# Access Compliance Report

## Public Rights-of-Way

### (Curb Ramps)

Intersection ID: 9709	Main Street: PARK_LN	Cross Street: TUCKASEEGEE_RD	Location:	E
ADA ID: B91CDF212988	Ramp Type: Directional1	Initial Pass/Fail: Fail	Overall Compliance: No	Severity Score: 22.5

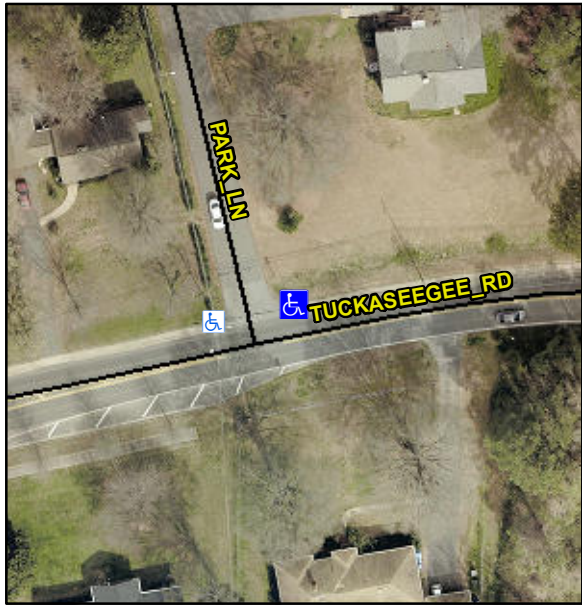
Codes/Mitigation Info/Possible Solution			Field Measurements/Component Compliance									
	Possible Solutions:		<b>Compliance</b>			<b>Description</b>			<b>Data</b>			
	<b>Remove &amp; Replace Entire Ramp.</b>		<b>N/A</b>	Ramp Length (in)		<b>86.5</b>	<b>N/A</b>	Grade Break?		<b>N/A</b>		
			<b>No</b>	Ramp Width (in)		<b>37.0</b>	<b>N/A</b>	Grade Break Slope (%)		<b>0.0</b>		
			<b>No</b>	Ramp Slope (%)		<b>11.5</b>	<b>N/A</b>	Grade Break XSlope (%)		<b>0.0</b>		
			<b>No</b>	Ramp XSlope (%)		<b>2.1</b>						
			<b>N/A</b>	Flare Type LT		<b>N/A</b>	<b>N/A</b>	Flare Type RT		<b>N/A</b>		
			<b>N/A</b>	Flare Slope LT (%)		<b>N/A</b>	<b>N/A</b>	Flare Slope RT (%)		<b>0.0</b>		
			<b>N/A</b>	Flare Traversable LT?		<b>N/A</b>	<b>N/A</b>	Flare Traversable RT?		<b>N/A</b>		
	Surveyor Notes:		<b>N/A</b>	<b>N/A</b>	Landing Length (in)		<b>0.0</b>	<b>N/A</b>	DWS Provided?		<b>N/A</b>	
				<b>N/A</b>	Landing Width (in)		<b>0.0</b>	<b>N/A</b>	DWS Contrast?		<b>N/A</b>

<b>N/A</b>	Landing Slope (%)		<b>0.0</b>	<b>N/A</b>	DWS Length (in)		<b>N/A</b>		
			<b>N/A</b>	Landing X Slope (%)		<b>0.0</b>	<b>N/A</b>	DWS Full Width?		<b>N/A</b>		
PROW/ADA:			<b>N/A</b>	Landing Curb? (Y/N)		<b>N/A</b>	<b>N/A</b>	DWS Offset LT (in)		<b>N/A</b>		
<b>R304.5.1, R304.2.2, R304.5.3</b>			<b>N/A</b>	Shared Landing?		<b>N/A</b>	<b>N/A</b>	DWS Offset RT (in)		<b>N/A</b>		
			<b>N/A</b>	Gutter Ponding?		<b>0.0</b>	<b>N/A</b>	Gutter Slope (%)		<b>N/A</b>		
			<b>N/A</b>	Gutter Lip Ht (in)		<b>0.0</b>	<b>N/A</b>	Gutter X Slope (%)		<b>N/A</b>		
			<b>N/A</b>	Painted X Walk1?		<b>No</b>		Road Slope (%)		<b>2.6</b>		
				X Walk 1 Direction		<b>To W</b>		Road X Slope (%)		<b>4.6</b>		
				X Walk 1 Width (in)		<b>N/A</b>		Clear Space?		<b>N/A</b>		
				X Walk 1 Slope (%)		<b>2.6</b>	<b>N/A</b>	Clear Space to XWalk (in)		<b>N/A</b>		
				X Walk 1 X Slope (%)		<b>4.6</b>	<b>N/A</b>	Storm Grate/Utility Hazard?		<b>N/A</b>

<b>N/A</b>	Ramp inside XWalk1?		<b>N/A</b>		Storm Grate/Utility Type				
			<b>N/A</b>	Any Obstructions?		<b>N/A</b>				<b>N/A</b>		
				Obstruction Type			<b>Yes</b>	Surface Condition? (G/P)		<b>Good</b>		
						<b>N/A</b>	<b>N/A</b>	Curb Slope (%)		<b>0.1</b>		
Street 1 Name		<b>PARK LN</b>										
Stop Condition-Street 1		<b>StopSign</b>										
Street 2 Name		<b>N/A</b>										
Stop Condition-Street 2		<b>N/A</b>										
Total Cost:		<b>\$ 1600.00</b>
